Addendum to New Installation of Two Pitch Clock Sets

From: Jason Hartman
Date: 2025-05-29
Regarding: First and Final Addendum

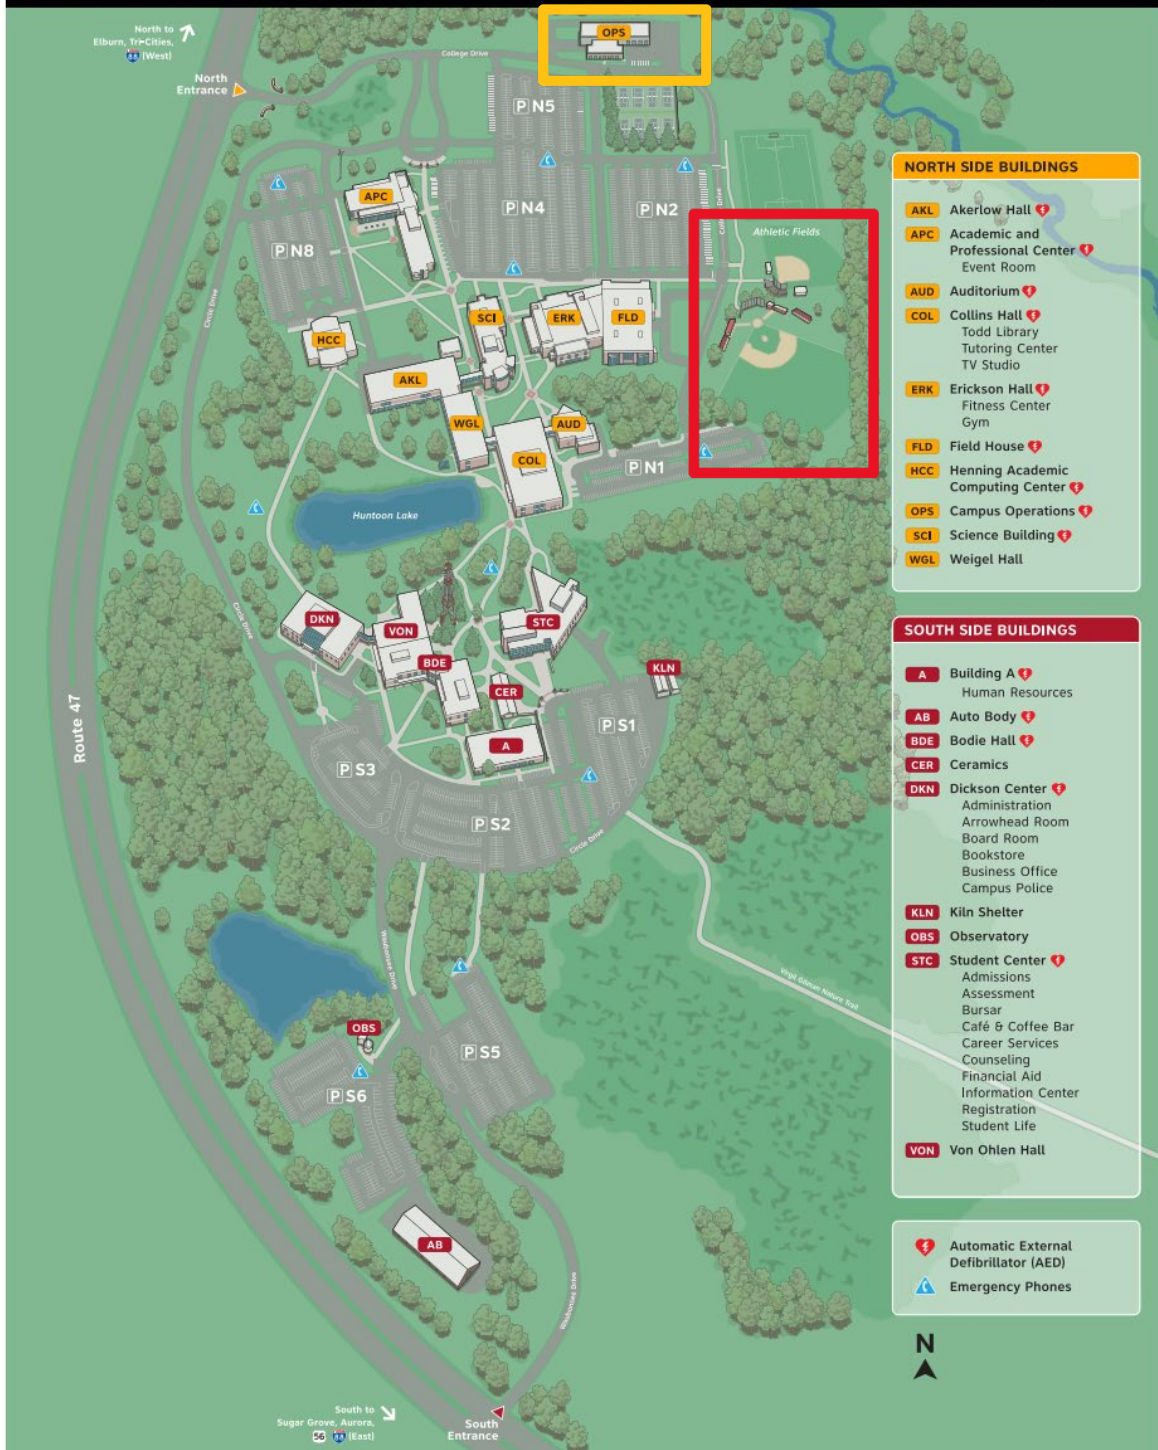
3. Change in Softball Infield Pitch Clock location due to structural strength concerns of original proposed location above fence line (Clock 4 in the Request for Proposal).

Answer: The updated, proposed location of the Softball Infield Pitch Clock is at ground level, integrated within the fence above the existing concrete pad (See below). While there is no standard for installation, the Athletics Department does not want the pitch clock behind the fence. This change will require fence work to create an opening in the fence and appropriate supporting chain link structure changes.

*****This change will also require proper all-weather padding on this specific pitch clock to protect players on the field-of-play side and to protect spectators on the bleacher side; please be aware of manufacturer requirements specifically with condensation potential.**
